CAPITAL PROJECTS DIVISION Addendum No. 1 Date: 09-09-2025 For: Drawings and Specifications For: CONTRACT NO. PRJ000371 SOUTHERN POLICE DISTRICT INTERIOR RENOVATIONS FOR THE MAYOR AND CITY COUNCIL OF BALTIMORE TO THE BIDDERS: THIS ADDENDUM IS HEREBY MADE A PART OF THE CONTRACT DOCUMENTS ON WHICH THE CONTRACT WILL BE BASED, AND IS ISSUED TO MODIFY, EXPLAIN AND/OR CORRECT THE ORIGINAL DRAWINGS AND SPECIFICATIONS. PLEASE ACKNOWLEDGE THIS ADDENDUM ON THE BID OR PROPOSAL PAGE WHERE INDICATED. **APPROVED: DESIGN PROJECT MANAGER** CONSTRUCTION PROJECT SUPERVISOR MalinMendonca **ENGINEER SUPERVISOR** Christopher A. Hepler **DIVISION CHIEF**

RESPONSES TO CONTRACTOR WRITTEN QUESTIONS SUBMITTED

CONTRACT NUMBER PRJ000371 SOUTHERN POLICE DISTRICT INTERIOR RENOVATIONS

SHEET P301

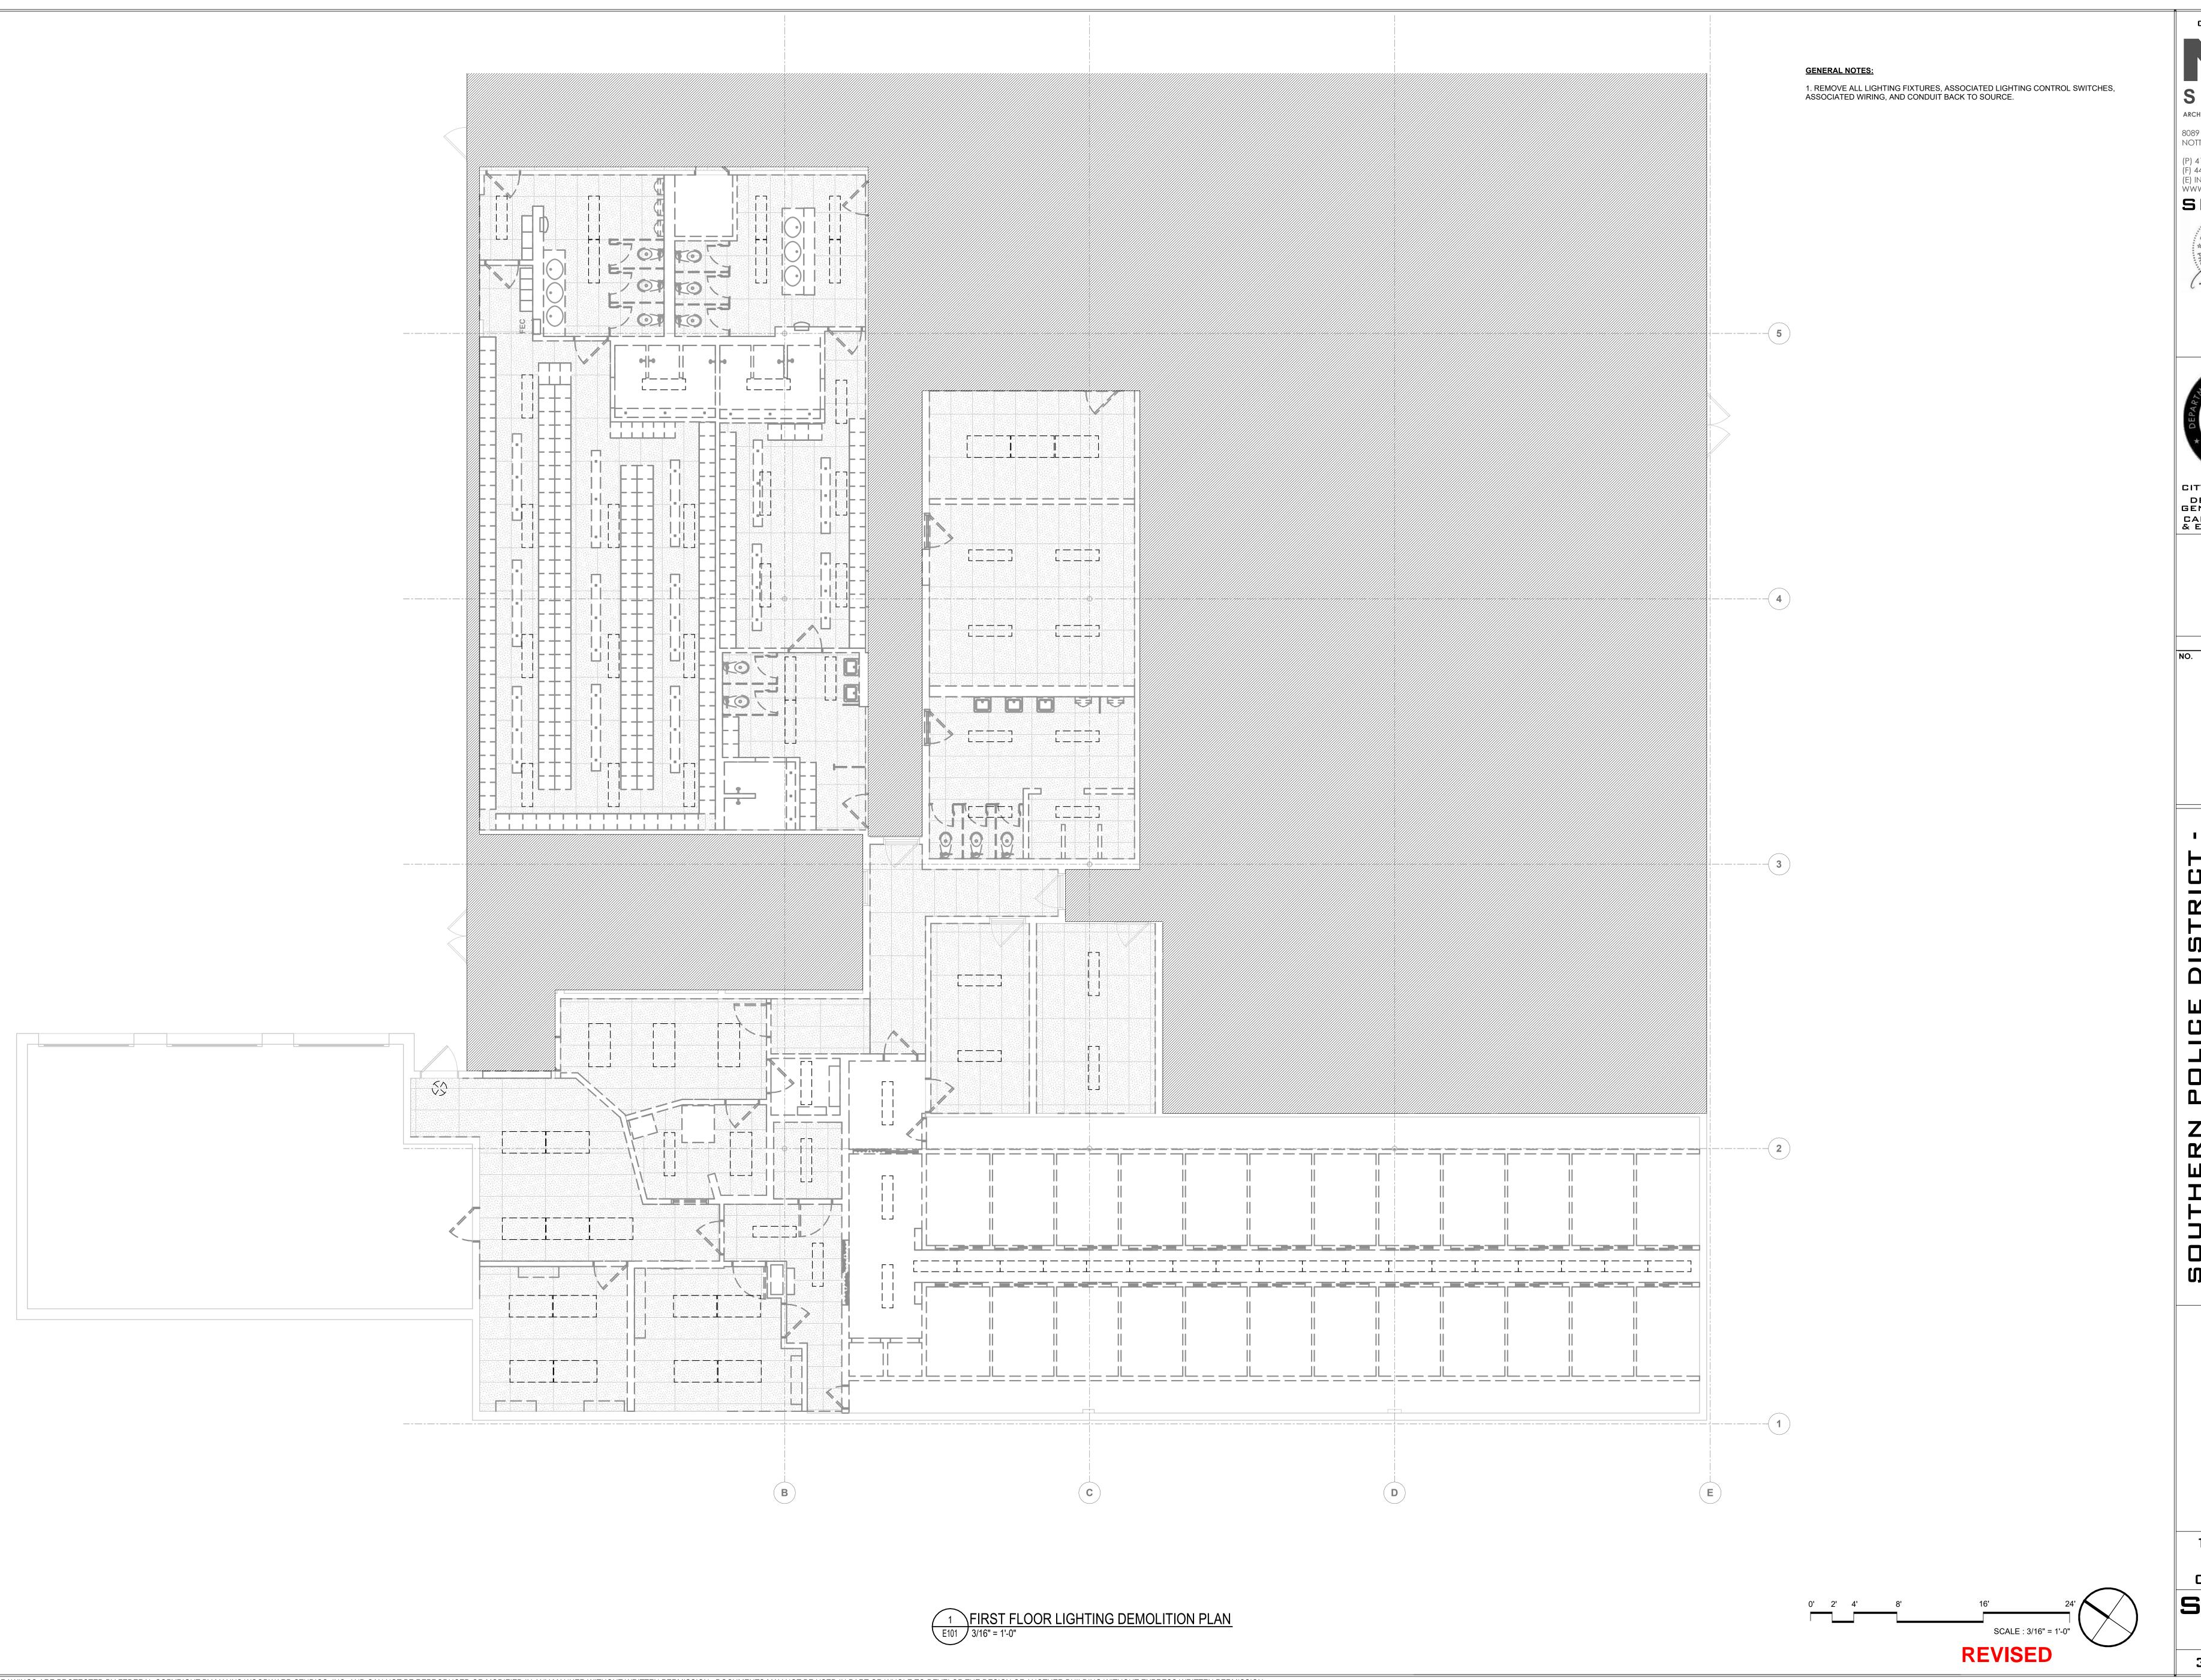
41.[P701, P301] Plumbing Specialties Schedule on P701 remarks that all Floor Drains are to include a Trap Guard. These generally eliminate the need for a water fed Trap Priming system. Please confirm whether Trap Priming Systems shown on P301 are required if we are already to provide Trap Guards per schedule.

44.[P301] Please revise the drawing to include an architectural floorplan so wall penetrations can be accounted for.

Response: Trap guard to be provided per P701 only where the trap primer with water connection is not provided in the plans.

Response: Revised MEP drawings with applicable backgrounds are now available.
